BID ADDENDUM NO. 3

Date of Addendum: February 1, 2023
Issued for Bid Date: January 3, 2022 (Bid Opening February 7, 2023)
Client Name: Eastchester Union Free School District
Project Name: 2022 Capital Bond Project, Phase 2
SED Project No.: Waverly School: 66-03-01-03-0-002-011
Greenvale Elementary School: 66-03-01-03-0-006-015
Anne Hutchinson Elementary School: 66-03-01-03-0-001-022
Eastchester Middle / High School: 66-03-01-03-0-003-030 / 66-03-01-03-0-003-029
MEMASI Project No.: 102-2202
Contracts: Contract No. 1 – General Construction (GC)
Contract No. 2 – Mechanical Construction (MC)
Contract No. 3 – Electrical Construction (EC)
Contract No. 4 – Window Construction Work (WC)

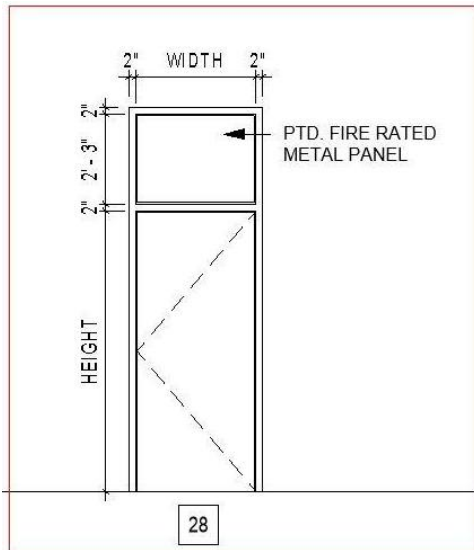
- 1b) Doors # K121B and K215 show glazing type 'I-5' is required, which is listed in the glazing specification 088000 section 2.4-E as a "2 hour rated fire resistive glass in rated framing system[I-5] – see specification 084900": These door types are shown to be a type 'N' Doors(manufactures of fire rated framing assemblies as specified in specification 084900 do not offer narrow light/half light or flush doors; they only offer stile and rail doors); also, the frame is shown as existing; how are we to determine if the existing frame will meet fire rated/heat barrier requirements?

I-5 is correct.

Refer to spec section 08416.

The frames were certified by UL.
